MICHIGAN DEPARTMENT OF
ENVIRONMENT, GREAT LAKES, AND ENERGY

April 16, 2026 CAG Meeting

Tannery

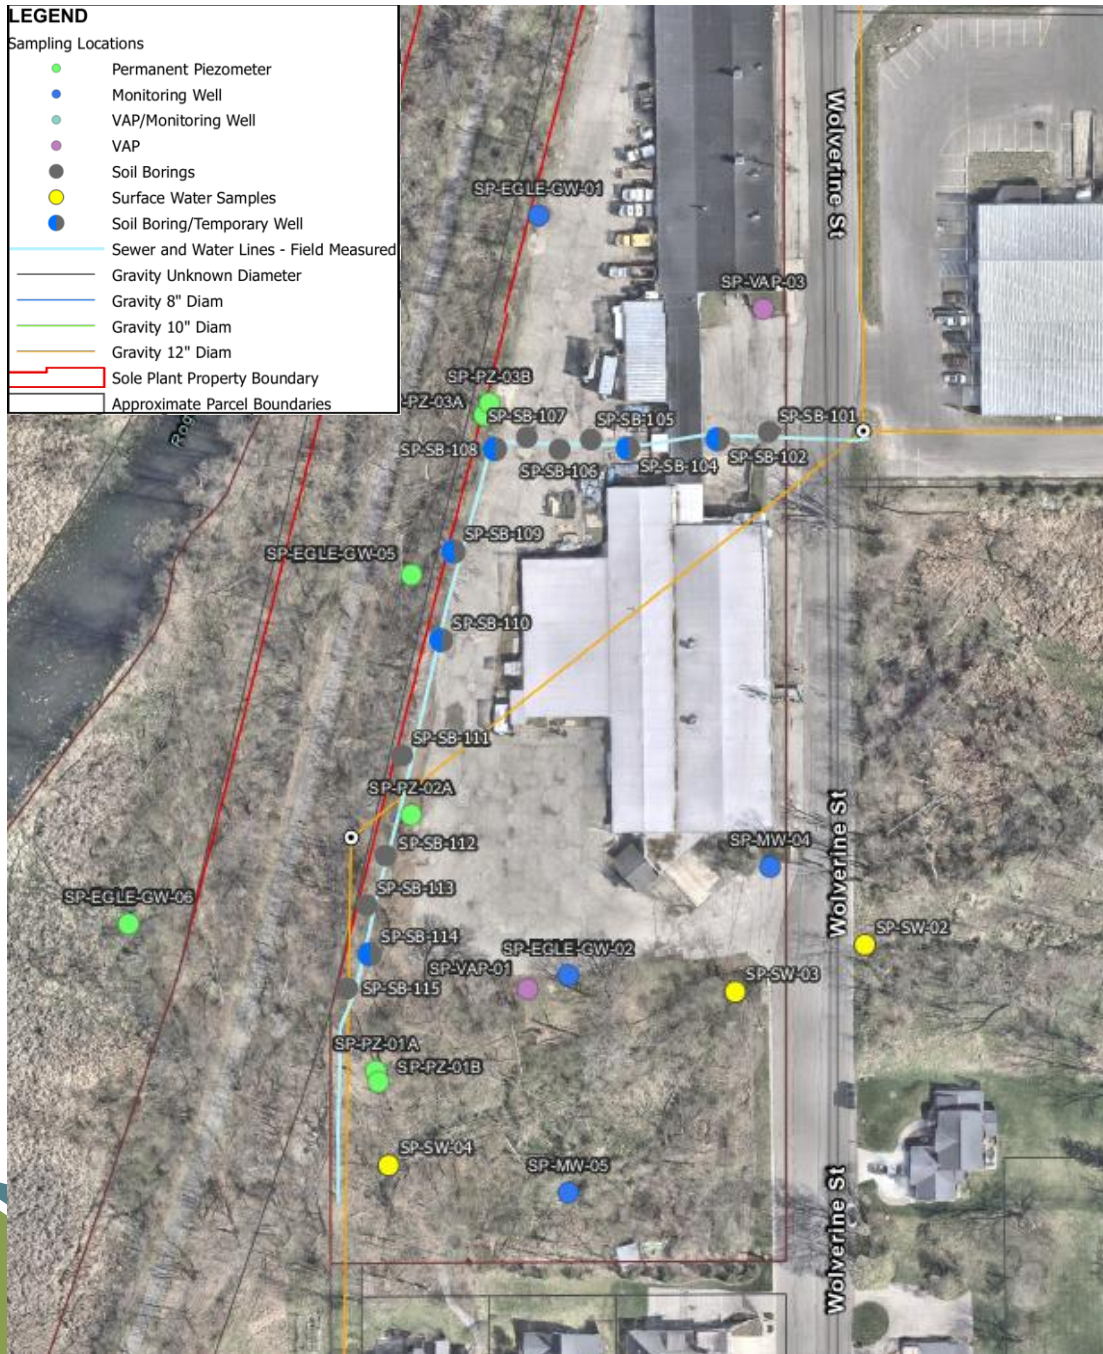
- **Section 12.0:** The storage of groundwater at the Property must comply with Part 121 of the Michigan Natural Resources and Environmental Protection Act (NREPA). Rule 12113(1) requires that storage of liquid industrial by-product shall be protected from weather, fire, physical damage, and vandals. The contaminated groundwater being stored and treated by the system is considered a liquid industrial by-product. Currently, many components of the treatment system can be accessed by the general public, which is adjacent to the Department of Natural Resources (DNR) White Pine Trail.

Although compliance with Part 121 does not have to include construction of a treatment building, the frac tanks and other components that store contaminated groundwater above ground at the Property must be protected from vandalism, physical damage, and weather elements. Since the construction of a permanent treatment system building is not occurring in the near future as previously proposed and approved in the September 20, 2023, Final Revised ResAP and the interim treatment system is being proposed as the long-term system, the treatment system must be fenced or otherwise secured. The Addendum should be updated to describe how the treatment system will be secured.

Information must also be provided in the long-term operation and maintenance plan on how the system will be inspected and protected from ultraviolet degradation and other weather elements. If an enclosed structure is not proposed for the final treatment system when the Tannery Interceptor System Completion Report is submitted, EGLE expects higher inspection frequencies to be proposed and higher long-term maintenance costs to be presented as part of the long-term operation and maintenance plan in the Completion Report submitted under Section 7.12(a)(iii).
